**ADDENDUM 2
TO THE CONTRACT PROVISIONS AND CONTRACT PLANS**

**CITY OF LONG BEACH
WASHINGTON AVENUE RECONSTRUCTION
(51ST STREET TO SID SNYDER DRIVE)
G&O #20430**

ISSUED THIS DATE: MONDAY, MAY 3, 2021

WATER MAIN TYPICAL TRENCH SECTION

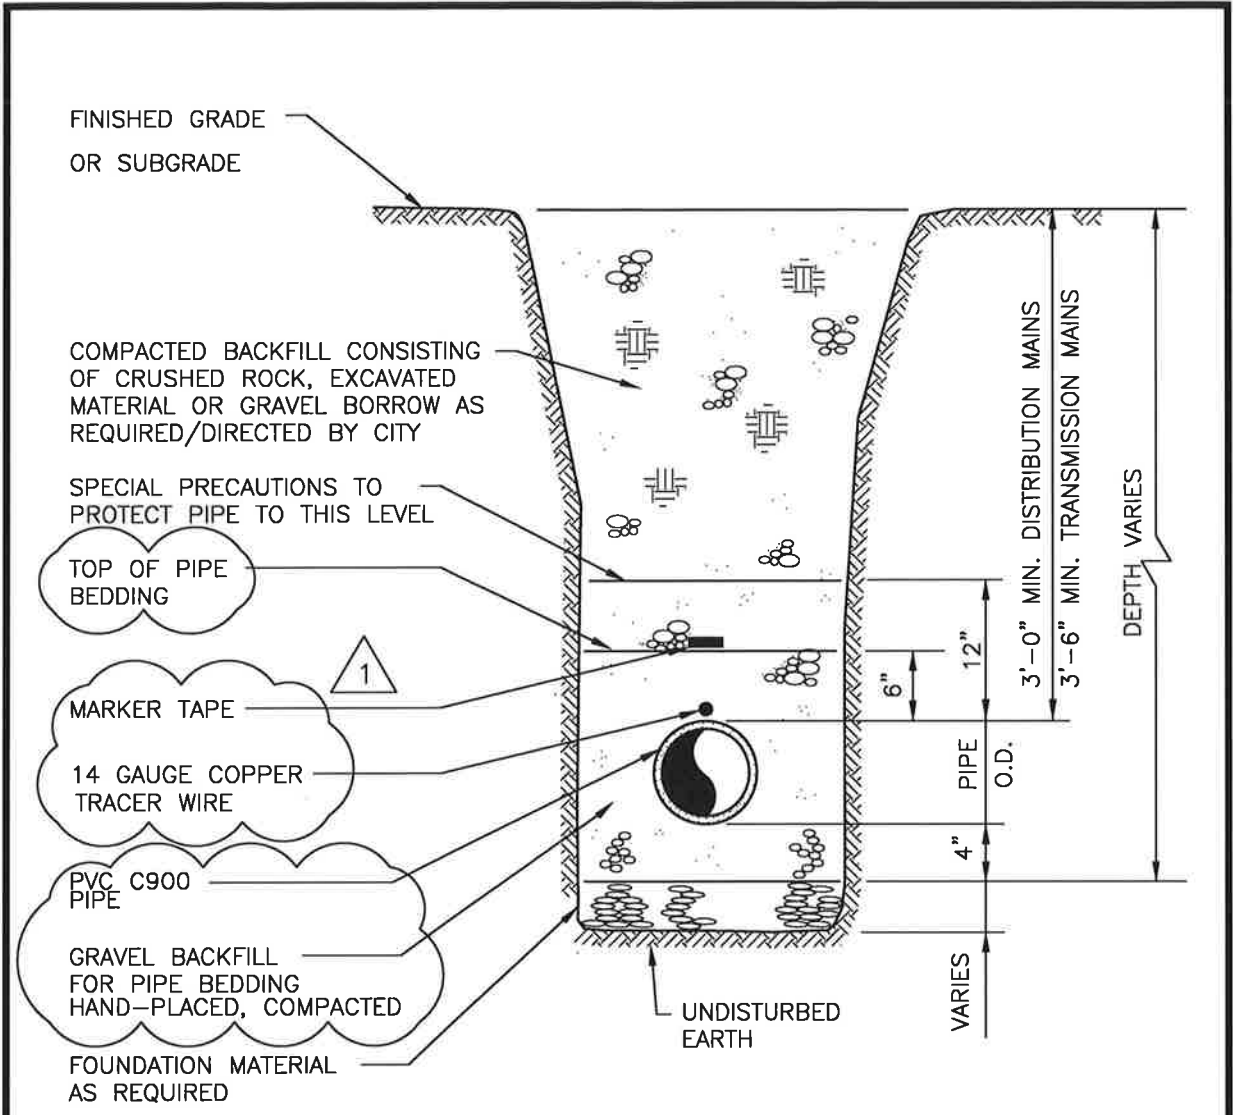
SHEET WD-1, WATER DETAILS

DELETE Detail 1 “Water Main Typical Trench Section” and **REPLACE** with the attached revised Detail 1 “Water Main Typical Trench Section”
